re: Geotechnical Response to City Comments
Proposed Mixed-Use Development
2 Robinson Avenue - Ottawa, Ontario

date: July 28, 2022

file: PG4811-MEMO.03

FIGURE 1

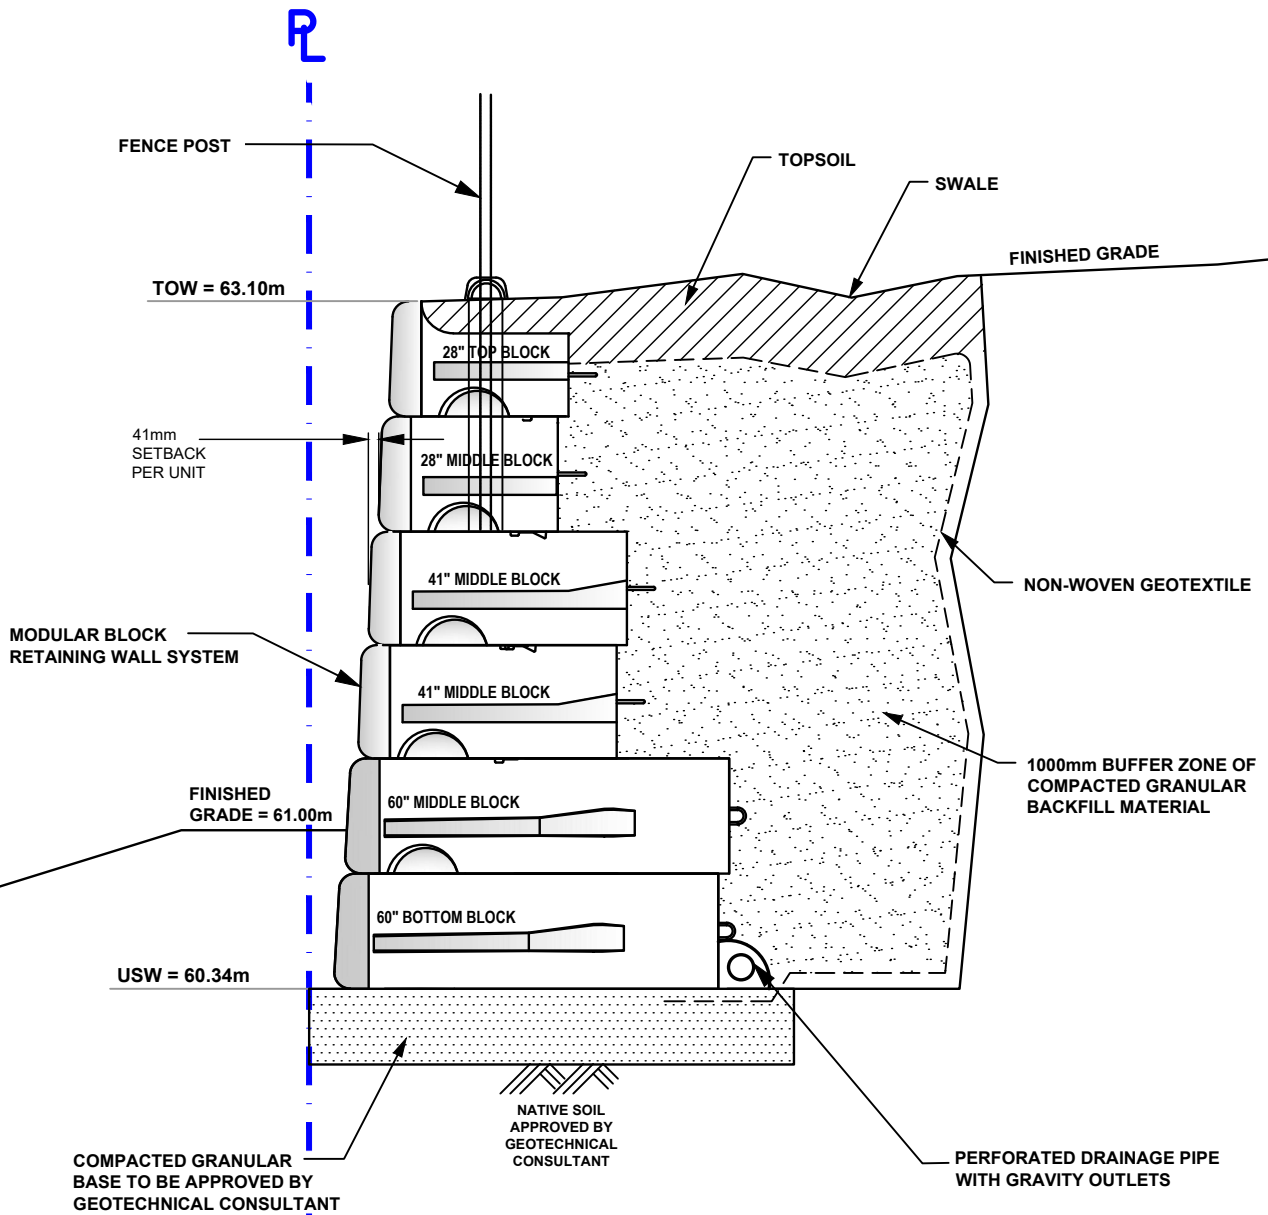
Comment 5: *Please provide global stability review, as per the latest Memo.*

Response: It should be noted that Paterson has not completed a detailed retaining wall design to date for the subject site and the following information is not representative of the final retaining wall design. The global stability review was prepared based on an anticipated retaining wall design for the proposed site grading as shown on the following drawing prepared by NovaTech:

Reference should be made to Figure 1 – Typical Cross Section and Figure 2 – Global Stability Analysis for Retaining Wall, attached to the current memorandum.

Based on the results of the analysis, the factor of safety for the proposed condition exceeds 1.5. It should be noted that as a conservative measure, the groundwater level for the global stability of the retaining wall assumed full saturation of the retained soil. The soil parameters utilized in our global stability review are outlined on Figure 2 – Global Stability Analysis for Retaining Wall.
